Administrative Order SWD-1300-A
July 5, 2012

**ADMINISTRATIVE ORDER
OF THE OIL CONSERVATION DIVISION**

Re: Administrative Order SWD-1300
September 2, 2011
ND 19 Federal SWD No. 1
30-015-39713
Sec. 19, T24S, R30E
Eddy County, NM

PROPOSED WELLBORE DIAGRAM

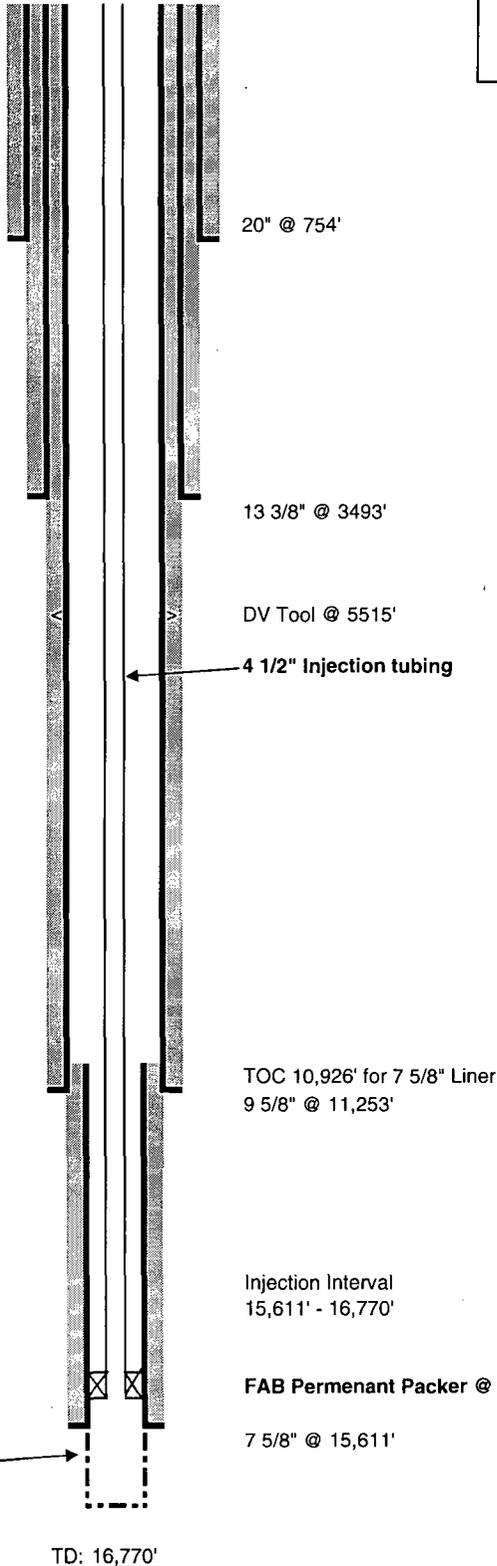
Sandra,
Just remembered, probably need an updated wellbore diagram showing the actual depths and actual well configuration.
I should already have asked for this,

Good afternoon Will – here is the diagram I sent in with the completion report, which is current. Please let me know of anything else you might need and I will get it to you. Have a nice day and thank you!
